PIC24FJ128GB204 Family Silicon Errata and Data Sheet Clarification

The PIC24FJ128GB204 family devices that you have received conform functionally to the current Device Data Sheet (DS30005009C), except for the anomalies described in this document.

The following typographic corrections and clarifications are to be noted for the latest version of the device data sheet (DS30005009C):

FIGURE 33-14: I²C BUS DATA TIMING CHARACTERISTICS (MASTER MODE)

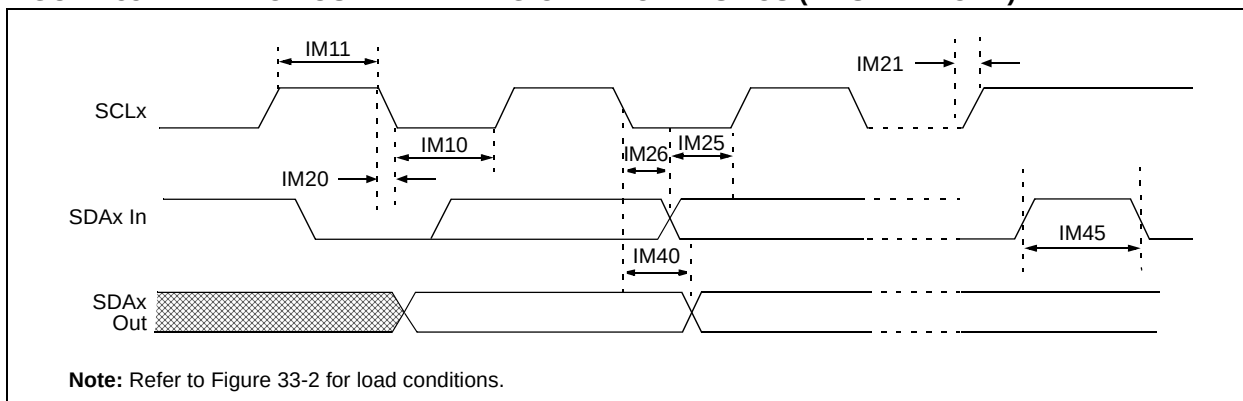
9. Module: I²C

Figure 33-14 and Figure 33-16 are modified as shown in the figures below.
